**Permit No: 9906997**  
**Insp Area: 2**

**Site Address: 857 WEST COVE WY SAC**  
Parcel No 031-1410-029

**Nature of Work: NEW 1 STORY 2615/700 SFR**

Subject: Clarification/Modification of Construction Details

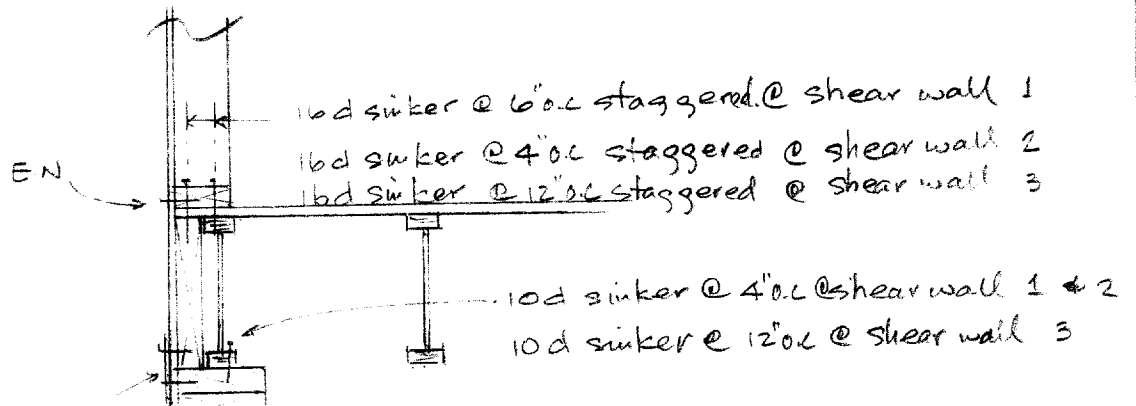
1. For 2x filler and 5/8" plywood shim at HD locations, 16ds and 8ds may be nailed randomly per guideline on attachment, pg. 1 of 6.
2. Lower floor connection detail, please see pg. 2 of 6.

Check 2x filler + of total lbd @ HD 8A w/4x

use 13-lbd for 2x filler  
w/ 3' length min

- end distance  $2\frac{1}{2} \sim 2\frac{3}{4}$ "
- edge distance  $1 \sim 3$ "
- spacing between rows of nails  $2 \sim 3$ "
- spacing between adjacent nails in a row  $3\frac{1}{2} \sim 9$ "

UPPER FLR CONN. DETAIL

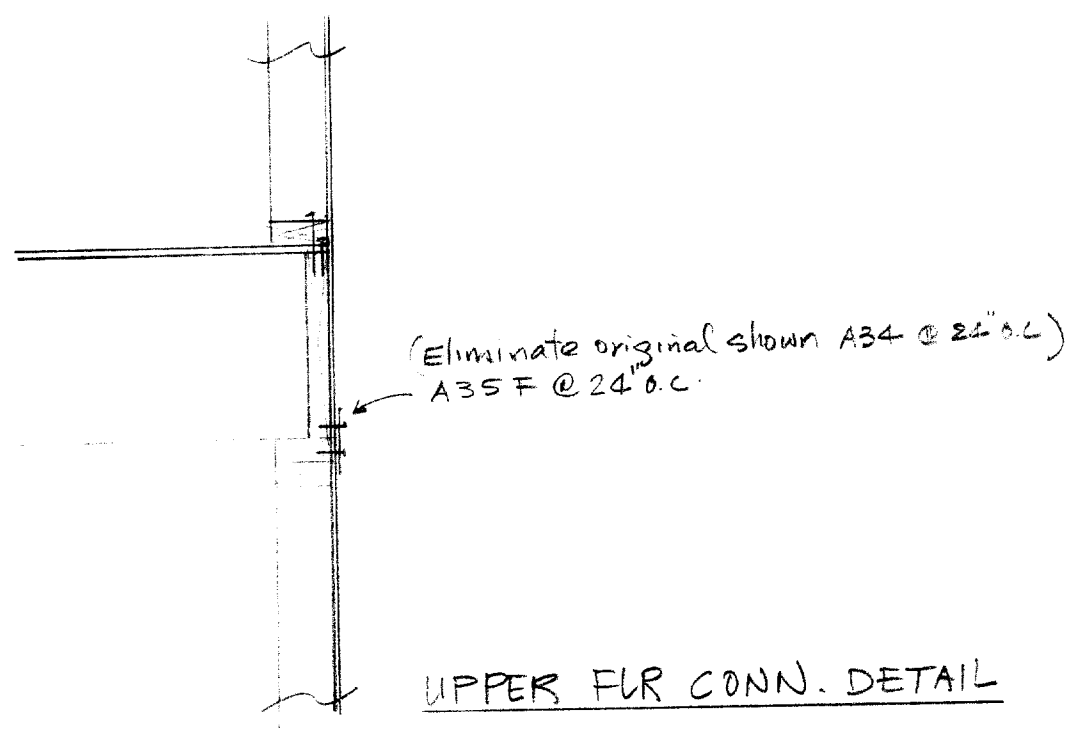
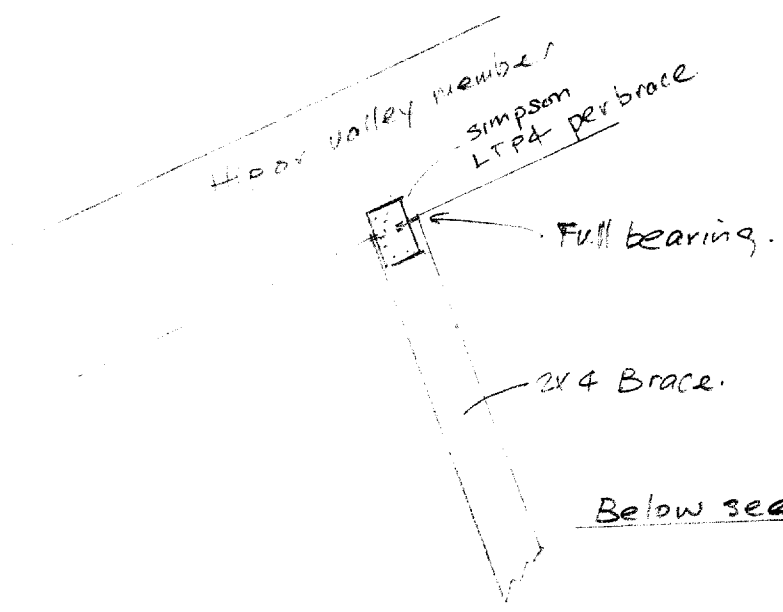
3. Upper floor connection detail, please see pg. 3 of 6.
4. Roof bracing plan above garage and bracing detail, pg. 4 and 3 of 6.
5. 5 1/2" x 18" balcony Glulam at 2x4 studs support, the width could be trimmed down to 3 1/2", since the beam is controlled by moment and deflection. Please see pg. 5 of 6.

Below see permit plan

Shear Wall Continuation @ Living Room wall

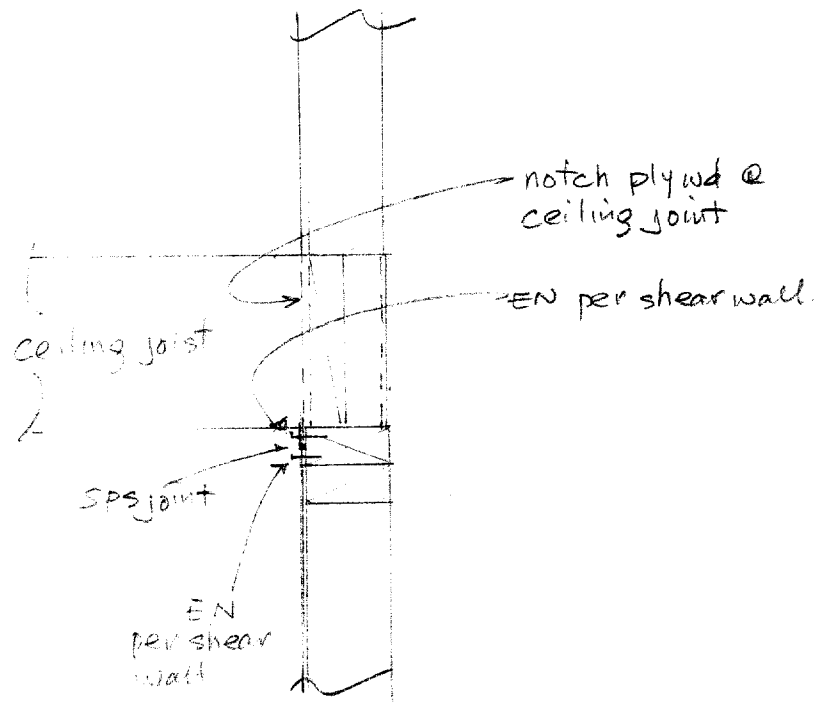
8. Detail of shear wall continuation at Living Room, please see pg. 6 of 6.
9. Simpson MST 48 or 60's nails, 10d common or 16d sinker may be used, for designed load is less than .80 of catalog loads.
